# Change Notice – Regulation 23

<b>Interest Holder</b>	Central Petroleum Limited	<b>EMP Title</b>	NT Drilling Campaign	<b>Unique EMP ID No.</b>	CTP 3.4	<b>Change No.</b>	1	<b>Date</b>	3 March 2021
<b>Brief Description</b>	<p>The NT Drilling Campaign EMP was approved by the minister on 29 November 2020. The plan included the development of well pads, access tracks and the associated infrastructure necessary to drill 2 development wells (WM27 and WM28) at Mereenie.</p> <p>In relation to the WM28 well, Central would like to notify the department of its intention to change the access track route to the well pad as approved in the EMP. The change notice is necessary as Sacred Site Clearance Certificate (SSCC) (C2020-009 - Appendix A) issued on 23 February 2021 by the Central Land Council (CLC) required under our land access agreement differs from the authority certificate (C2020/084 - Appendix B) granted on 25 November 2020 by the Aboriginal Areas Protection Authority (AAPA).</p> <p>As outlined in Appendix C, the CLC have amended the route of the access track to WM28 (CLC – blue / AAPA yellow) by 75m to the north east avoid some culturally sensitive areas, they have also included restr

### Proposed West Mereenie 28 clearance area

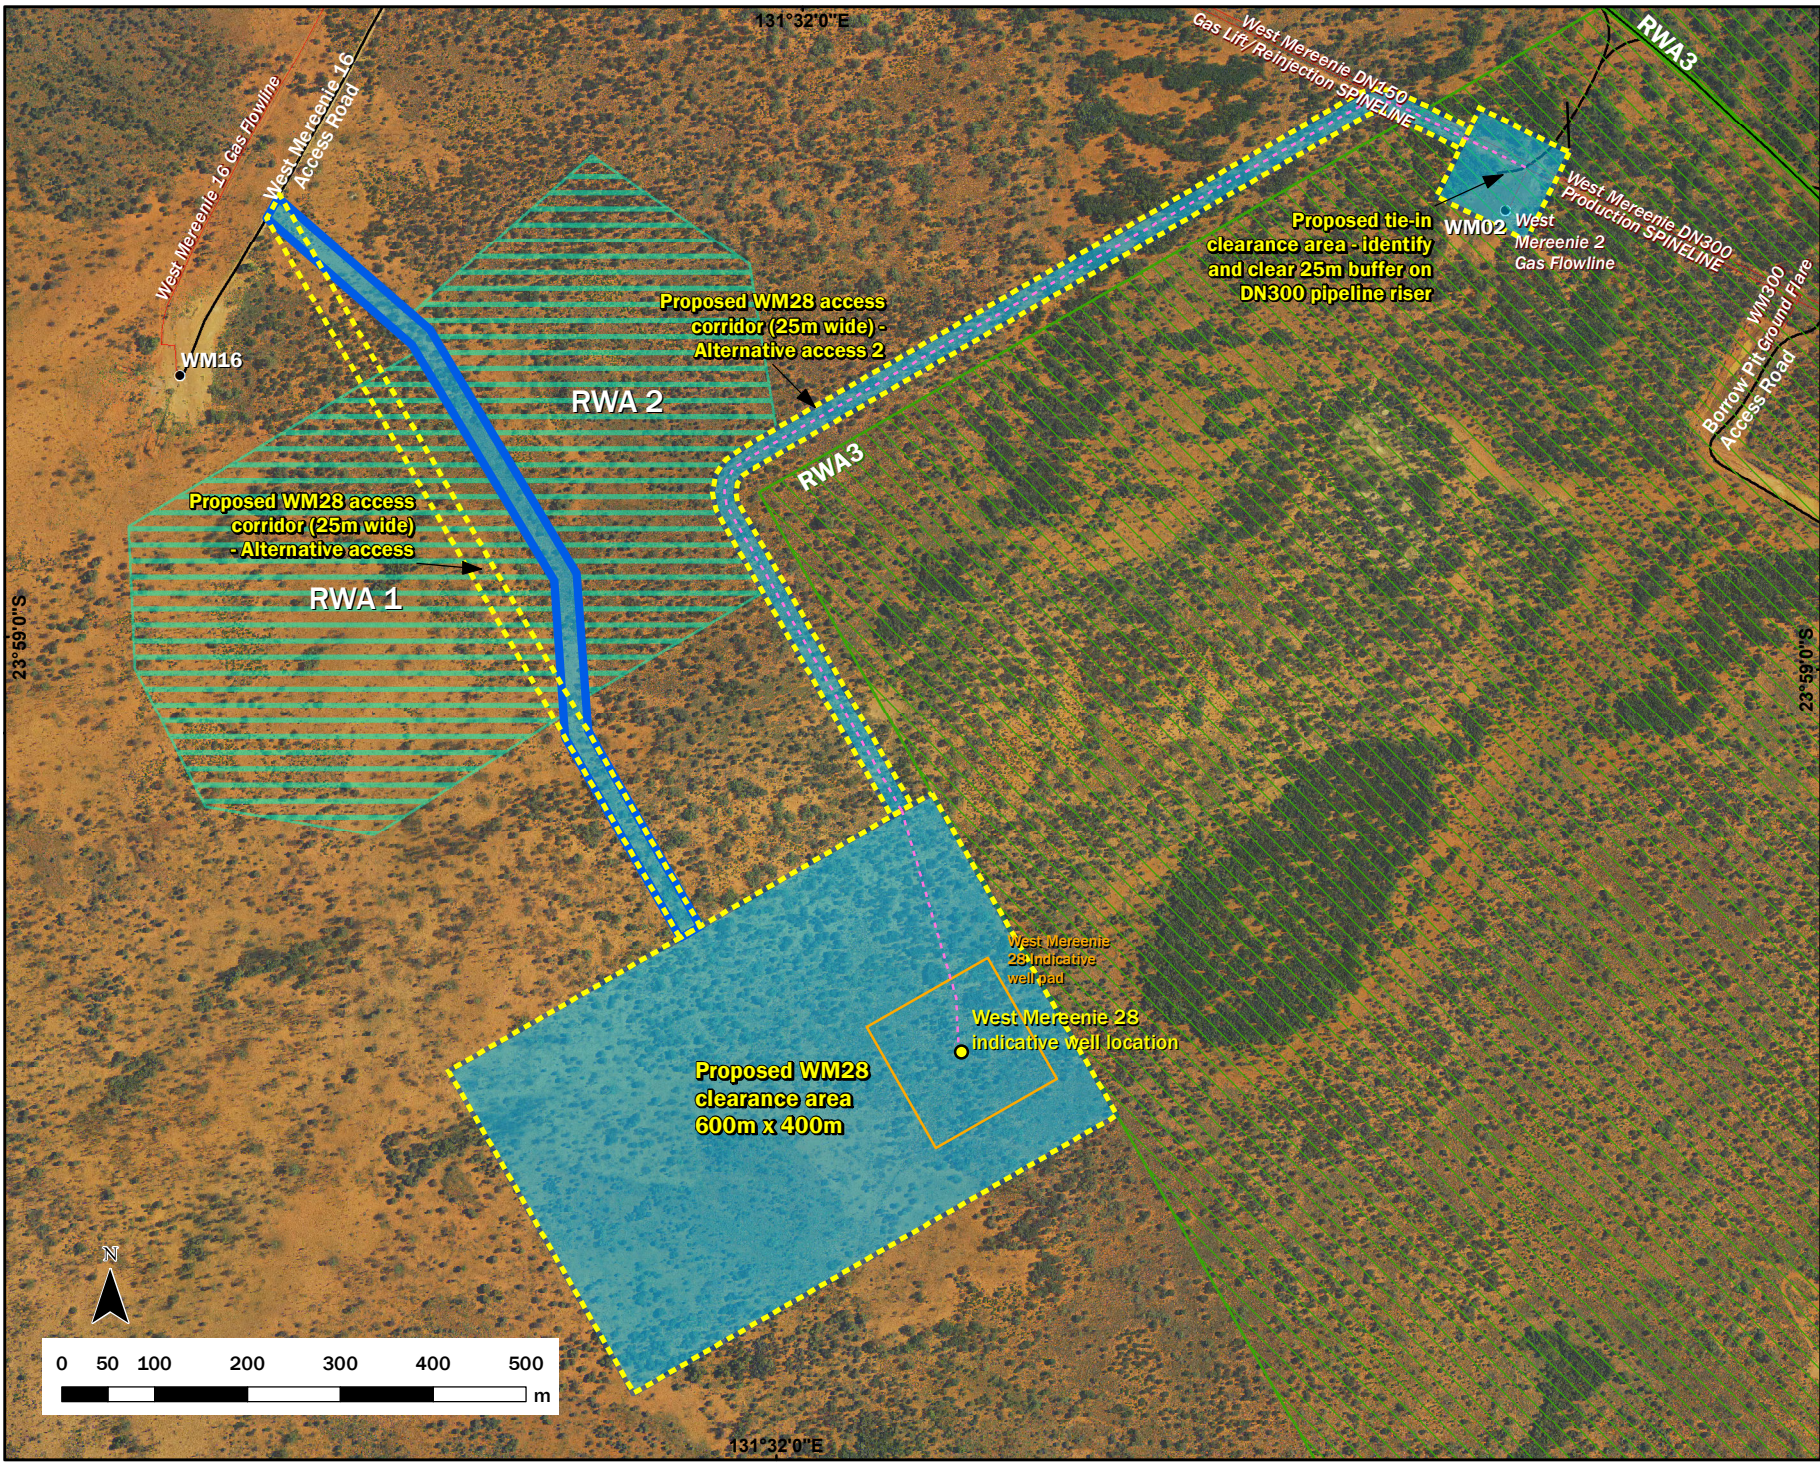
Current EMP Text	Amended EMP Text
<p><b>Figure 4-3 – Clearance Area (West Mereenie 28 Well)</b></p>	<p><b>Figure 4-3 – New Clearance Area (West Mereenie 28 Well)</b> The access track location in this map has been updated (Appendix D) to highlight the new access track route / location to the WM-28 well. The new route aligns with CLC and AAPA authority certificates.</p>
<p><b>Figure 5-15 Land Types (West Mereenie 28 Well)</b></p>	<p><b>Figure 5-15 Land Types (West Mereenie 28 Well)</b> The access track location in this map has been updated (Appendix D). The new route avoids the highlighted sand dunes within the proposed western access corridor and aligns with CLC and AAPA authority certificates.</p>
<p><b>5.2.3.5.3 Aboriginal Sacred Sites</b> In accordance with the <i>Aboriginal Sacred Sites Act 1989</i>, CP has lodged an Authority Certificate application with the AAPA for the West Mereenie wells (application # 202000411). CP commits to complying with the requirements of the granted Authority Certificate. Additionally, CP will also obtain a Sacred Site Clearance Certificate from the Central Land Council for the West Mereenie wells.</p>	<p><b>5.2.3.5.3 Aboriginal Sacred Sites</b> In accordance with the Aboriginal Sacred Sites Act 1989, CP was granted an Authority Certificate (C2021/084) by AAPA for the West Mereenie wells on 25 November 2020. Subsequently, a variation was submitted to allow for alignment between CLC scared site clearance certificate (C2020-009) and AAPA authority certificate (application no. 202102907) One approved, CP commits to complying with the requirements of both the:</p> <ul style="list-style-type: none"> <li>▪ AAPA granted Authority Certificate; and</li> <li>▪ Sacred Site Clearance Certificate from the Central Land Council.</li> </ul>

**Note 1:** Minor increase in risk given the road length is now 927m as opposed to the previously approved 900m road and there will be a greater area of disturbance (216 sqm). However, all of the proposed activities are currently included as part of the scope of the current approved EMP.
